Subject: paper NCOMMS-16-26092 - Response to reviewers.

Manuscript#: NCOMMS-16-26092C

Title: From a freshwater lake to a salt-water sea causing widespread hydrate dissociation in the Black Sea

Distribution of the chlorinity of pore water at the DSDP hole 379A in the central plain of the Black Sea (modified from Meray and Sinayuc, 2016 and Calvert and Batchelor, 1978). This figure was integrated to the Supplementary Fig 2.

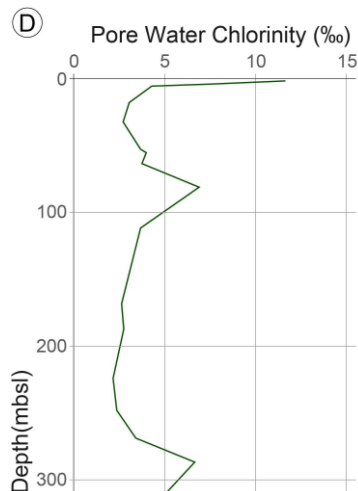
1) The claims are not however convincing because of the lack of data to constrain the salinity at the BSR. The salinity profile is indeed limited to the first meters of sediments and far away from the BSR. This preclude to understand whether the GH are in a stable conditions. The authors should provide evidence of this. If the salinity at the BSR is close to the one of the seabed the GH are stable and will not dissociate in the near future.

Sediment pore water salinity was acquired during the 379 DSDP project (hole 379A – Calvert and Batchelor, 1978) and salinity data are available from the first 600 mbsf. The calculation carried out in the present work considered the first 250 m of sediment while the sediment thickness affected by the salinization of the sediment during the next 5000 years period concerns only the first 50 m. The results of the simulation shown in the previous version of the paper remain unchanged by introducing in the calculation the real pore water salinity shown below where the salinity increases slightly at round 80 mbsf.
